Access Compliance Report

Public Rights-of-Way

Intersection ID: 3991	Main Street: BRIDGEPATH_TL	Cross Street: DOWNING_CREEK_DR	Location: SE
ADA ID: A8ABE9095DD7	Ramp Type: BlendTrans1	Initial Pass/Fail: Fail	Overall Compliance: No
Severity Score: 10			
Codes/Mitigation Info/Possible Solution		Field Measurements/Component Compliance

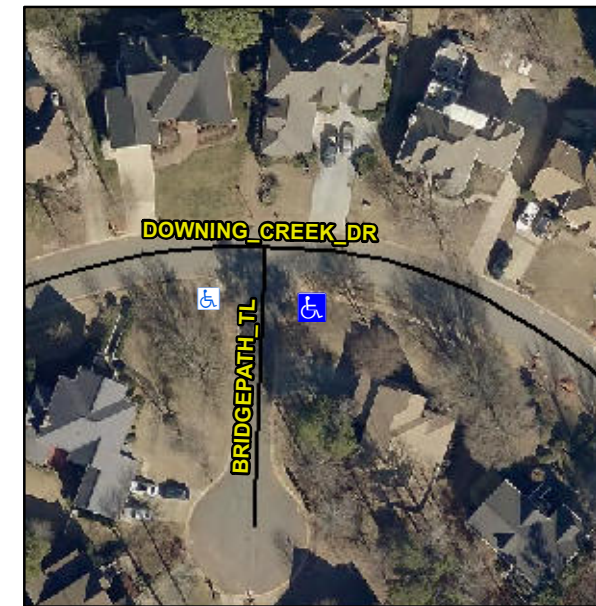
Not Found, R304.5.1, R304.5.3

Compliance	Description	Data	Compliance	Description	Data
N/A	Ramp Length (in)	14.5	Yes	BlendTrans Slope (%)	1.3
No	Ramp Width (in)	47.5	No	BlendTrans XSlope (%)	4.6
N/A	Flare Type LT	N/A	N/A	Flare Type RT	N/A
N/A	Flare Slope LT (%)	N/A	N/A	Flare Slope RT (%)	N/A
N/A	Flare Traversable LT?	N/A	N/A	Flare Traversable RT?	N/A
N/A	Landing Length (in)	N/A	N/A	DWS Provided?	N/A
N/A	Landing Width (in)	N/A	N/A	DWS Contrast?	N/A
N/A	Landing Slope (%)	N/A	N/A	DWS Length (in)	N/A
N/A	Landing X Slope (%)	N/A	N/A	DWS Full Width?	N/A
N/A	Landing Curb? (Y/N)	N/A	N/A	DWS Offset (in)	N/A
N/A	Shared Landing?	N/A			
N/A	Gutter Ponding?	N/A	N/A	Gutter Slope (%)	N/A
N/A	Gutter Lip Ht (in)	N/A	N/A	Gutter X Slope (%)	N/A
N/A	Painted X Walk1?	No	N/A	Painted X Walk2?	N/A
	X Walk 1 Direction	To W		X Walk 2 Direction	N/A
	X Walk 1 Width (in)	N/A		X Walk 2 Width (in)	N/A
	X Walk 1 Slope (%)	4.5		X Walk 2 Slope (%)	N/A
	X Walk 1 X Slope (%)	4.6		X Walk 2 X Slope (%)	N/A

N/A	Ramp inside XWalk1?	N/A	N/A	Ramp inside XWalk2?	N/A
	Road Slope (%)	4.6		Clear Space?	N/A
	Road X Slope (%)	4.5	N/A	Clear Space to XWalk (in)	N/A
N/A	Any Obstructions?	N/A	N/A	Storm Grate/Utility Hazard?	N/A
	Obstruction Type			Storm Grate/Utility Type	
		N/A			N/A
			Yes	Surface Condition? (G/P)	Good
			No	Curb Slope (%)	18.1

Remove & Replace Curb Ramp With Two New Directional Ramps or Equivalent.
